REMARKS

Application Number: 10/601,721
Amendment Dated: April 25, 2005
Reply to Office Action of February 25, 2005

Fig. 1

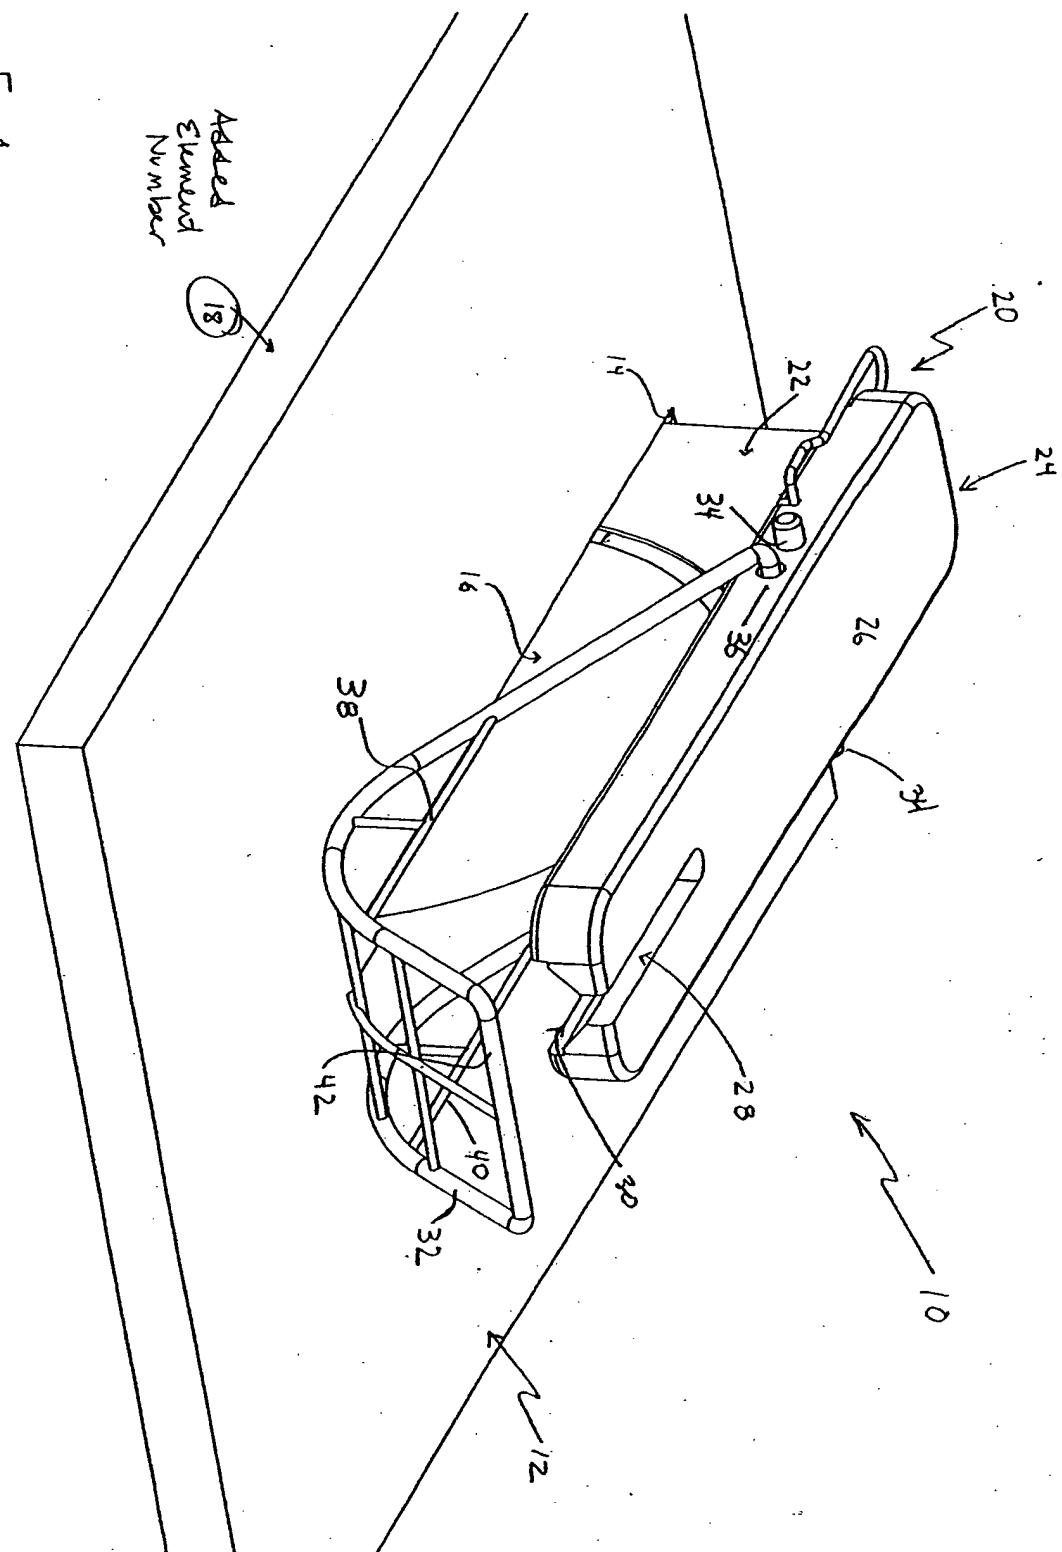
The Examiner objected to the drawings under 37 CFR 1.83(a), stating that the term "frame" as set forth in claims 1 and 17 must be specifically shown in the drawings. The Examiner stated that the replacement sheets filed with the Applicants' Amendment of November 15, 2004 were unacceptable because changes were made that were considered new matter because there was no support in the original disclosure for the specific structure added to the drawings. The Applicants respectfully disagree with the Examiner's contention.

no basis in the original disclosure for the changes made to FIGs. 1 and 4 by replacement sheets 1 and 2 that were filed with the Amendment. The Examiner's next logical step was to determine that because there was no basis for the changes made in the replacement sheets, there was no basis for the amendments that were made to the specification.

Claims 1-11 and 17-20 were rejected by the Examiner under 35 U.S.C. § 112, second paragraph as being indefinite for failing to particularly point out and distinctly claim the subject matter which applicants regard as the invention. Claims 1-11 and 17-20 were rejected because the Examiner stated that the terms "frame" in claims 1 and 17 are vague and indefinite as to what the term refers to. The applicants have amended FIGs. 1 and 4 to show the frame as element 18 and amended paragraphs [0022] and [0023] of the specification to identify the frame with element 18 and state that the table saw includes a frame. The applicants believe that amended FIGs. 1 and 4 and the description of the frame in the specification overcomes this rejection.

In order to expedite prosecution of the application, replacement sheets 1 and 2 that were included with the Applicants' Amendment of November 15, 2004 have been withdrawn. Applicants submit revised replacement sheets 1 and 2, which modify FIGs. 1 and 4, respectively. The only change on both replacement sheets from the as-filed figures is the addition of element 18, which identifies the frame, through which the saw blade extends and of which the table top is a part. The structure that element 18 refers to was shown in the as-filed versions of FIGs. 1 and 4. Because claims 1 and 17 each include limitations to a "frame having a table top" and as-filed FIGs. 1 and 4 each included the structure of the frame by showing the table top, and the replacement sheets, which only add the designation of element 18, do not add any new matter to the application. See MPEP § 608.01(l).

In order to expedite the prosecution of this application, the Applicants cancel the amendment made to paragraph [0022] in the Amendment filed on November 15, 2004. In place of the cancelled amendment, the Applicants have amended paragraph [0022] as set forth earlier in this Amendment. The current amended paragraph [0022] has the exact language that was used in as-filed claims 1 and 17 to describe the frame, in addition to the reference to element 18, which refers to the frame on the replacement sheets (corresponding to FIGs. 1 and 4, filed with this Amendment).
